CITY PLANNING COMMISSION

APPLICATION: Special Permit to allow a drive-thru facility for a proposed bank in the C-2 zone.

LOCATION: Southwest portion of Mack Road at Valley Hi

CROCKER NATIONAL BANK
Sacramento, CA

EXHIBIT A

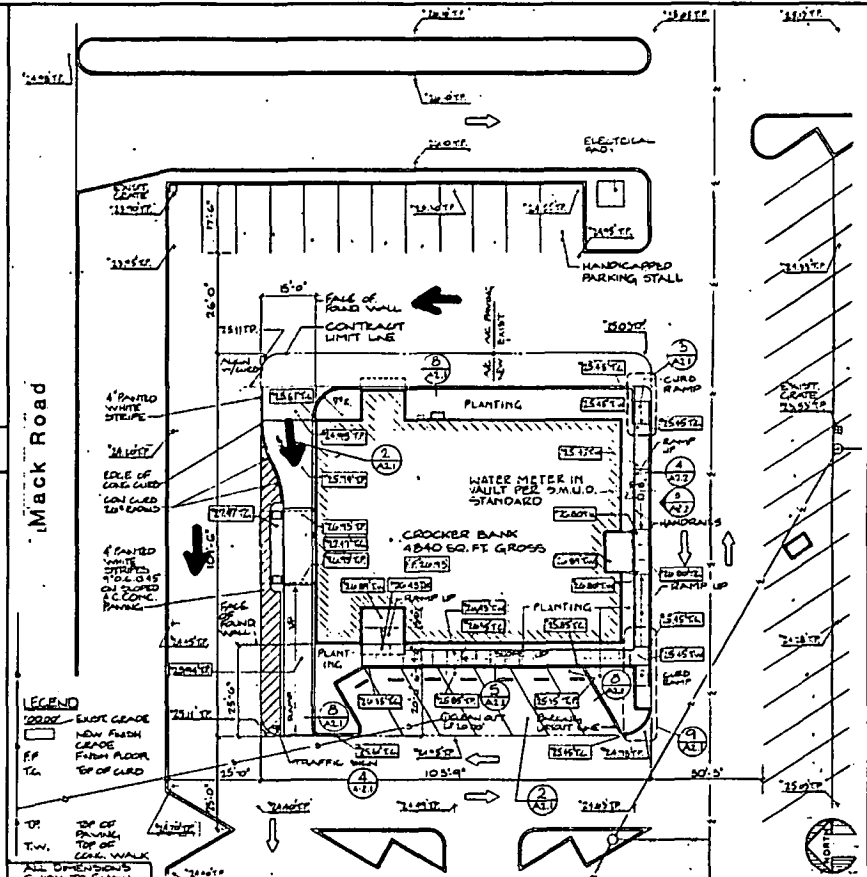
1. City Traffic Engineering Office has reviewed the proposed drive-thru plan and has determined that the presently proposed 7-foot wide drive-thru lane is inadequate and that a minimum 10-foot wide lane is necessary.

The site plan indicates one-way traffic around the east and north side of the proposed structure. Traffic notes the impracticality of drivers maintaining this and also the potential conflict with two-way use and the drive-thru stacking area. One solution to assure one-way traffic is to reduce the "one-way" lane and angle the

eastern parking in the direction of traffic. Traffic is also concerned about the narrow and barely visible curbing at either outside end of the drive-thru lane. An area at least 4-feet wide and planted would be more visible. Reducing the one-way lane would allow widening of the drive-thru lane and provision of a wide planter. (See Exhibit A). Redesign of the drive-thru area is necessary and should be submitted to staff for review and approval prior to building permit issuance.

4. The area between the drive-thru lane and the driveway (north) is indicated on the site plan as 4" painted white stripes on sloped A. C. concrete paving. To be in keeping with the planted setback along Mack Road, this area should be planted with trees, shrubs and groundcover to soften the area between the maneuvering lane and drive-thru lane. (See Exhibit A).

- * 1. The site plan shall be revised per Exhibit A/and submitted to planning staff for review and approval prior to issuance of building permit.
2. The proposed signs shall comply with the City Sign Ordinance.
3. A detailed landscape/shading/irrigation plan shall be submitted to staff for review and approval prior to issuance of building permit.
4. That area between the drive-up lane and the driveway (north) shall be planted in trees, shrubs and groundcover as indicated in Exhibit A.
5. Detailed building elevations shall be submitted for review and approval by staff prior to building permit issuance.
6. A parcel map shall be submitted and approved prior to occupancy approval.
